# SERVICE BULLETIN

SERVICE BULLETIN NO: 28-009

## FUEL - DISTRIBUTION FUEL BOOSTER PUMP - DAMAGE TO WIRES DURING INSTALLATION

Lead Protection - Installation  
Figure 1

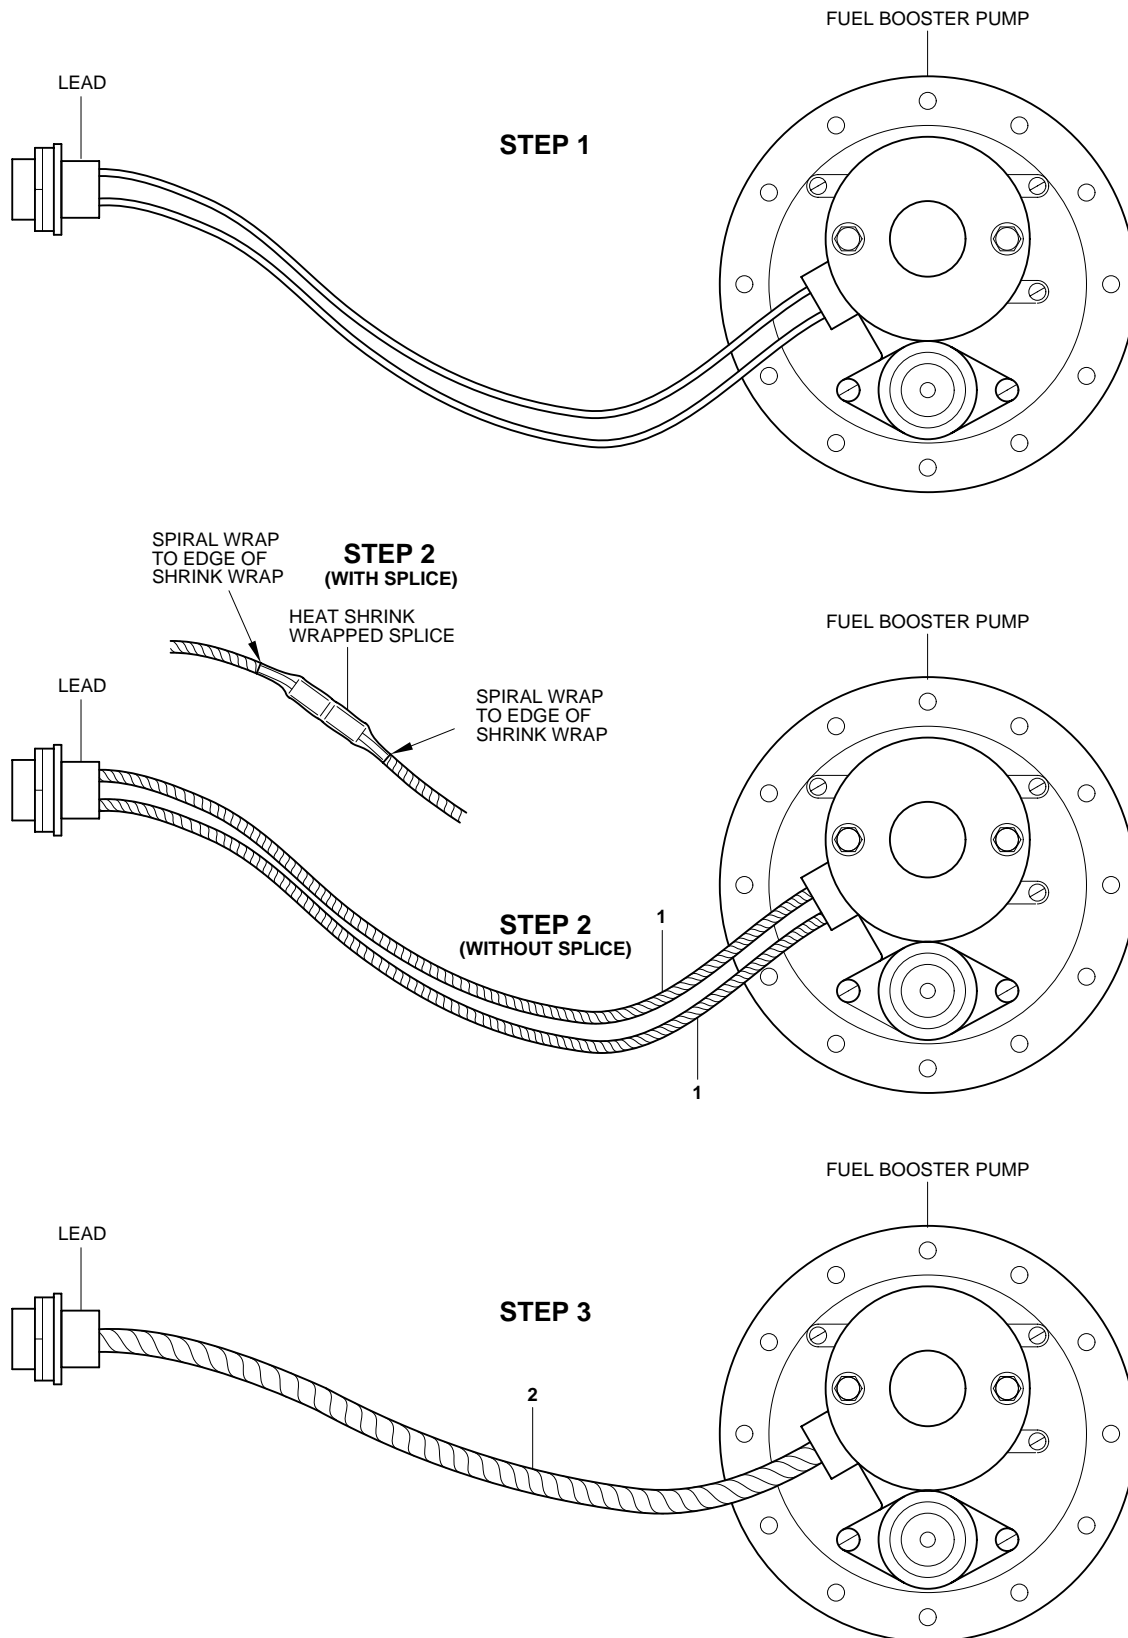
- (2) Install the spiral wrap on each wire:
  - (a) For a wire with no splice. Wind spiral wrap (1) around the full length of the wire. Twist the spiral wrap (1) to make sure there are no gaps and cut the spiral wrap (1).
  - (b) For a wire with a splice. Wind spiral wrap (1) around the wire between the edge of the shrink wrap and the end of the wire. Twist the spiral wrap (1) to make sure there are no gaps and cut the spiral wrap (1). Do this for each side of the splice.
- (3) Release the black wire and the white wire.
- (4) Wind the spiral wrap (2) around the full length of the black wire and the white wire. Twist the spiral wrap (2) to make sure there are no gaps and cut the spiral wrap (2).

- (3) Install the spiral wrap on each wire:
- (a) For a wire with no splice. Wind spiral wrap (1) around the full length of the wire. Twist the spiral wrap (1) to make sure there are no gaps and cut the spiral wrap (1).
- (b) For a wire with a splice. Wind spiral wrap (1) around the wire between the edge of the shrink wrap and the end of the wire. Twist the spiral wrap (1) to make sure there are no gaps and cut the spiral wrap (1). Do this for each side of the splice.
- (4) Release the black wire and the white wire.

- (5) Wind the spiral wrap (2) around the full length of the black wire and the white wire. Twist the spiral wrap (2) to make sure there are no gaps and cut the spiral wrap (2).
- (6) Reidentify the fuel pump Part No. 968.84.11.401, 968.84.11.403 or 968.84.11.404 when this Service Bulletin is done. Use a stamp or vibropen to put the letter B immediately after the Serial Number on the fuel pump Identification plate.
